(This Service Bulletin is FAA D.O. Authorization SW-1 Approved)

- SUBJECT:** Rework of Cabin Sealing on M20F
- MODELS AFFECTED:** M20F S/N 670001 thru 670116, 670118 thru 670120, 670122, 670124 thru 670126, 670128 thru 670131, 670134 thru 670136, 670138, 670141, & 670144.

- TIME OF COMPLIANCE:** At Owner's Option
- INTRODUCTION:** There have been reports of cold air leaks in the rear seat area of the M20F which are particularly noticeable during winter operation. This bulletin describes areas which have been found to be sources of air leaks in some aircraft and defines rework required.

FIGURE 1

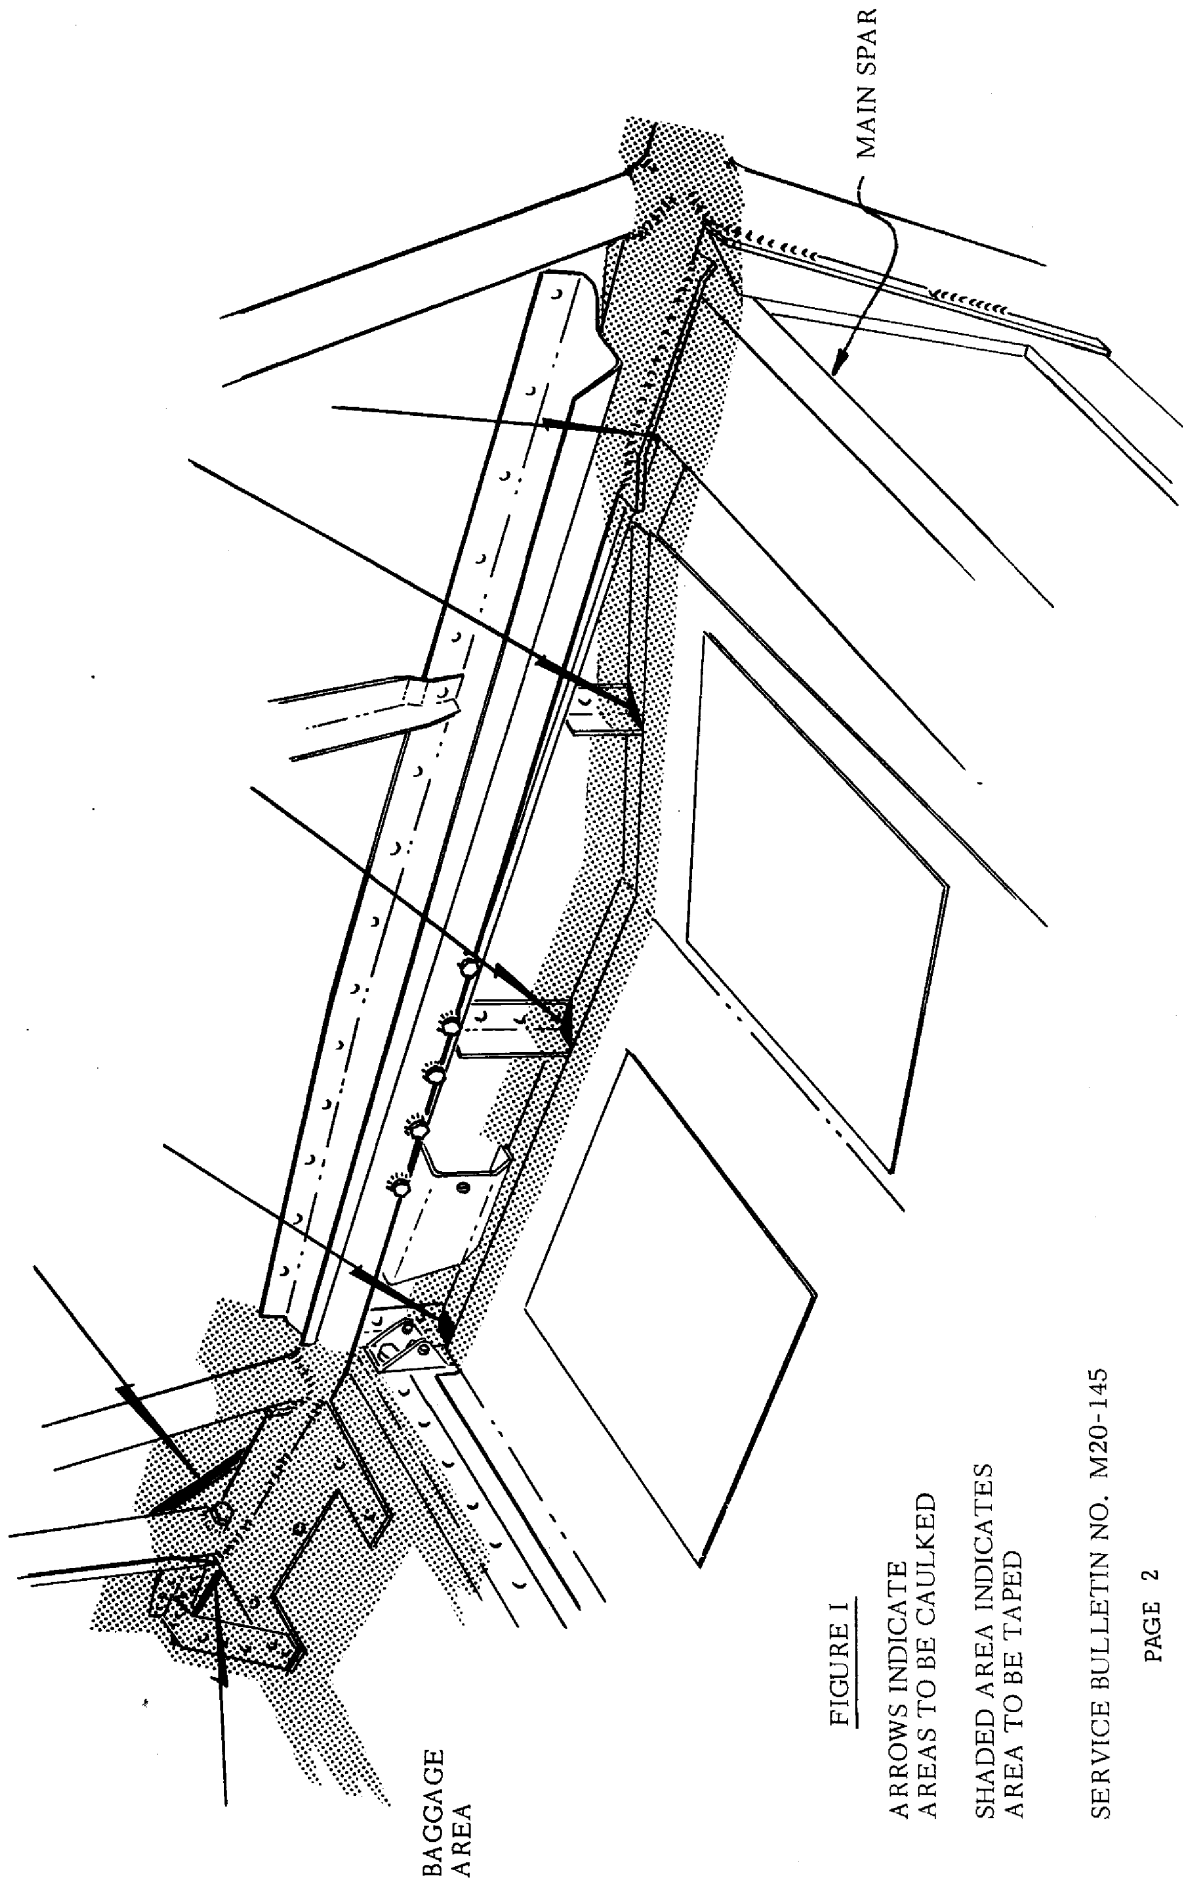
- INSTRUCTIONS:**
1. Remove rear seat backs and bottom cushion. Remove baggage compartment side panels.
  2. Figure 1 describes the "sealing line" at the left and right sides junctions which separates cold, higher pressure air in the belly area from the cabin in the vicinity of the rear seat. Check both left and right sides of these areas for any obvious leaks before starting the rework.

3. Remove the gray plastic tape from the area shown, from the baggage compartment (just aft of the tail cone attachment) to the main wing spar.
  4. Fill in areas specified by the arrows in Figure 1 with calking (Scotch Calk or equivalent) as required to seal irregular holes and gaps. The area near the baggage floor extension has been found to have leakage and also the joint between the rib cap and main spar cap under the Tubular Structure.

5. Finish sealing the area indicated in Figure 1 with Permacel #12 aluminum foil tape (or equivalent) as shown by the shaded area.
  6. Check for leaks where radio cables and vacuum lines pass through the rear baggage bulkhead on the left side of the aircraft, and seal with calking and tape as required.

ARROWS INDICATE  
AREAS TO BE CAULKED

SHADED AREA INDICATES  
AREA TO BE TAPED
